# WASH 3.5 Modification

Version 1.0, 17-04-2020

WASH 3.5, FCC ID: 2ADS4WASH

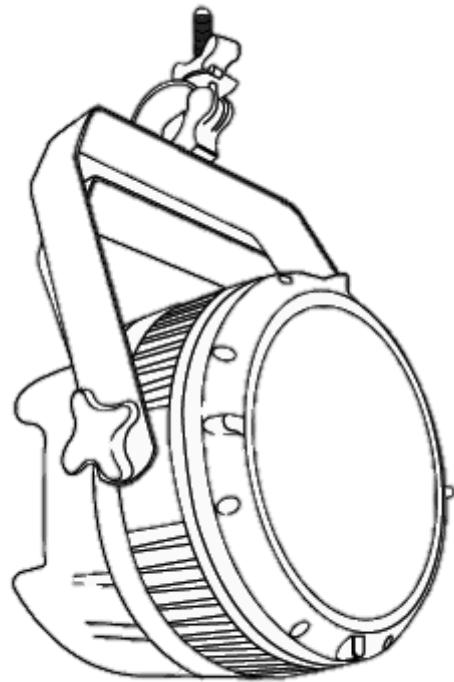
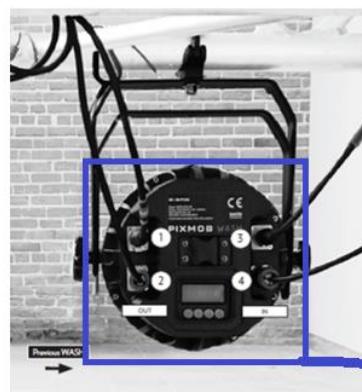
This picture shows the modification for the WASH 3.5 (final version). Previously there was one small Ferrite per cable on the DMX cable (2 in total) with no turn and 1 big Ferrite per cable on the POWER cable (2 in total). They were changed for 4 bigs Ferrites: 74271221 from Würth Elektronik. And there is a loop for the input and output of the DMX cable (see images below).
